WEST OXFORDSHIRE DRAFT LOCAL PLAN (2012)

LANDSCAPE AND VISUAL REVIEW OF SUBMISSIONS FOR CARTERTON AND WITNEY STRATEGIC DEVELOPMENT OPTIONS

October 2012

FIGURE 1A: CARTERTON

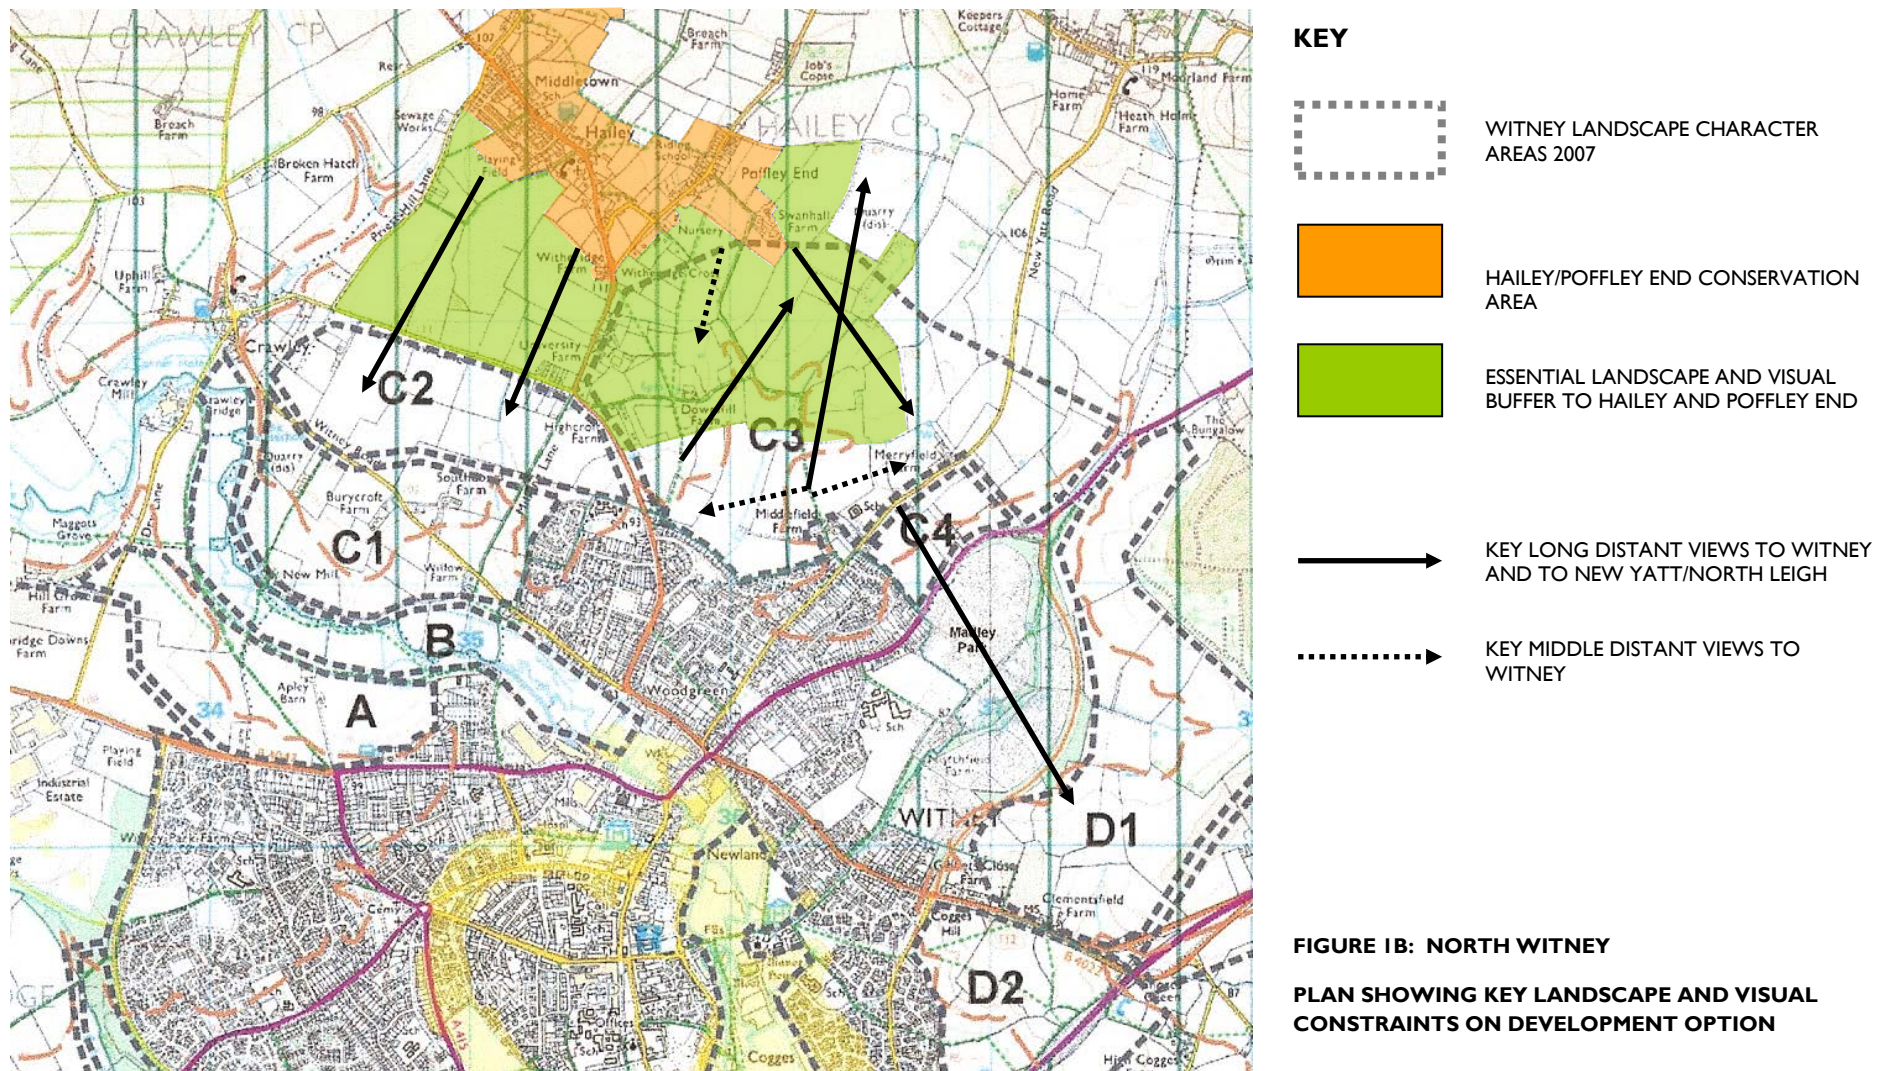
- Provide a landscape transition zone between the site and Brize Norton to protect the character of the village and its landscape setting as shown in Figure 1A. Detailed landscape analysis should be used to determine the final width;

Landscape setting of Brize Norton	South-east corner falls within landscape buffer to Brize Norton – see Figure 1A	The most south easterly portion of the development intrudes into this gap	The very small open space is inadequate to maintain the separation of Brize Norton and Carterton	Any development should include an extension to the green infrastructure of the park within the landscape transition zone

FIGURE 2B: NORTH WITNEY

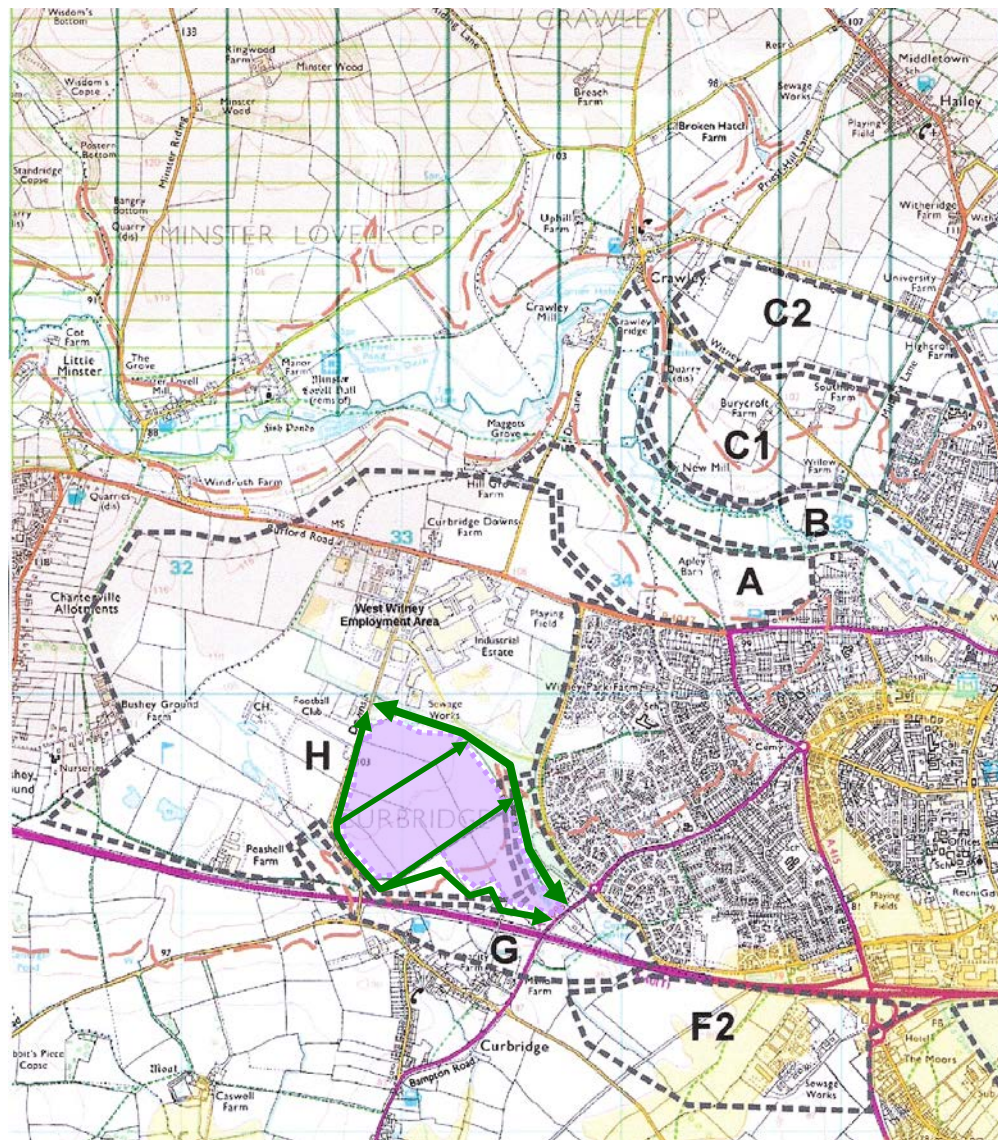
Sense of tranquillity away from urban edge of Witney	Further erosion of tranquillity within Wychwood Project Area	X	Pull development south away from Downhill Farm (see Figure 2B) to protect sense of tranquillity south of Poffley End.
	Individual buildings in wooded skyline (Middlefield Farm and school)	Development north of Middlefield Farm creates urban skyline above 95m AOD contour northwards away from Witney	Landscape buffer retained on slightly higher ground	Reinforce woodland planting to create dominant wooded skyline
C4 North Witney: Plateau	Low intervisibility with wider landscape; and from adjacent road network due to hedgerow and tree cover	Limited visual impact in views from the open countryside	Retained hedgerow helps to conserve low intervisibility	Reinforce visual containment on eastern boundary with woodland planting

Dispersed farmsteads	No farmsteads within development footprint. However, development brings urban edge much closer to scattered farmsteads and envelops Middlefield Farm into urban form	X	Pull development south away from Downhill Farm (see Figure 2B). Retain open landscape link between Middlefield Farm and Merryfield Farm.
	Modern school with playing fields adjacent to C4	Incorporated into layout	Incorporated into open space between development and existing built form	X
	Scattered development along the B4022 including Witney Rugby Ground	Brings urban form much closer to Highcroft Farm	Landscape buffer to B4022	Reinforce contrast between scattered farmsteads in farmland and built form of Witney through major woodland planting south of Highcroft Farm.
	Urban form set down in lower slopes of valley north of river Windrush	Urban form will extend beyond 100m AOD and up northern arms of the valley slopes	X	Pull development south away from Downhill Farm (see Figure 2B) and below 100m AOD.

- The provision of playing fields could be accommodated on the periphery of the development in the vicinity of Middlefield and Downhill Farms provided the field pattern and provision of major landscape infrastructure is also achieved (see Figure 2B);

The potential area to be considered further is shown in Figure 2B.

This report concludes that, provided a substantive landscape transition zone is retained next to Hailey/Poffley End as shown in Figure 2B, this option could be developed on a smaller scale as an extension to the existing built form. The landscape character is already influenced by the existing urban edge and the site could be partly developed without harm to the wider landscape. A number of recommendations seek to protect and improve the urban edge and local landscape features.

FIGURE 2C: WEST WITNEY

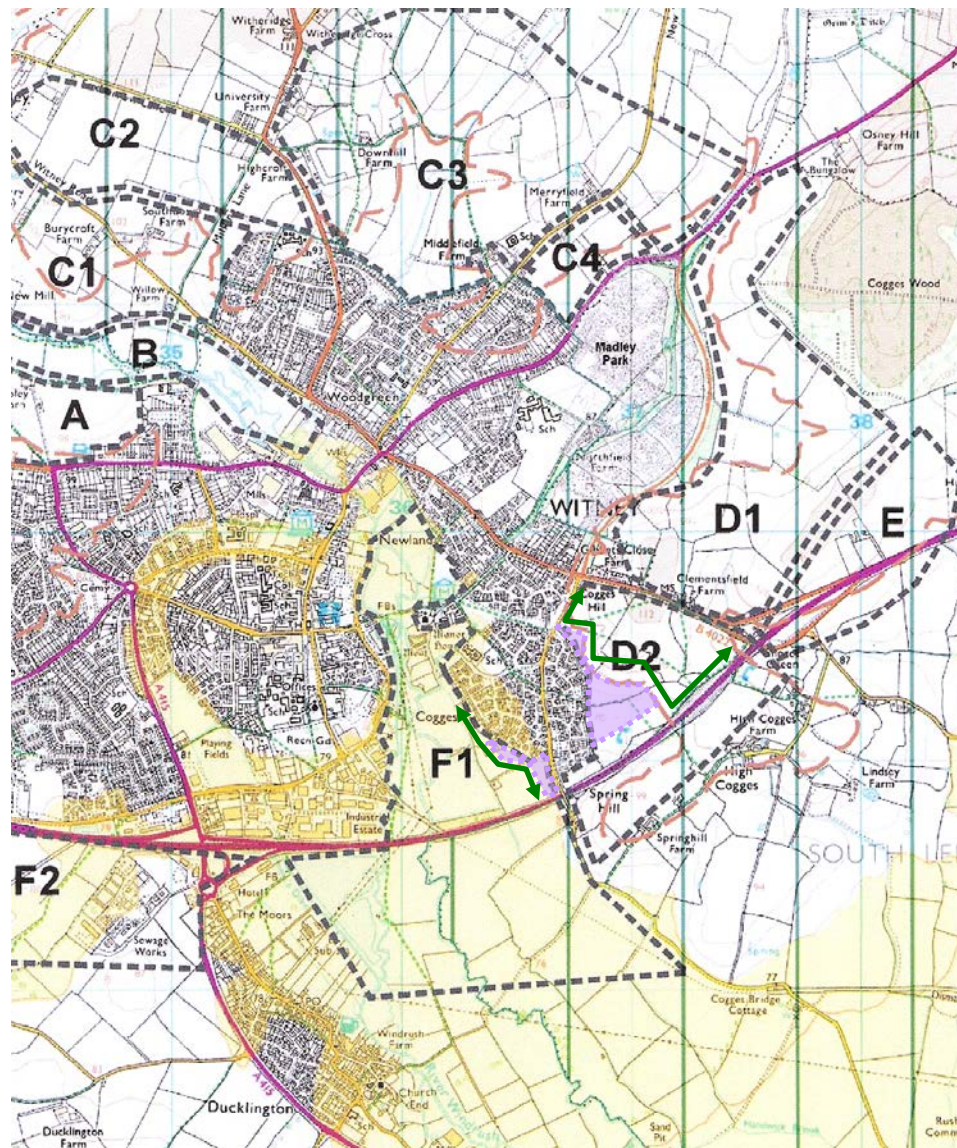
- Frontage development along Downs Road and Curbridge Road as shown in Figure 2C to be designed to enhance the quality and character of the approach to the town, having regard to the adjoining landscape character and key characteristics of the town;

The potential area to be considered further is shown in Figure 2C.
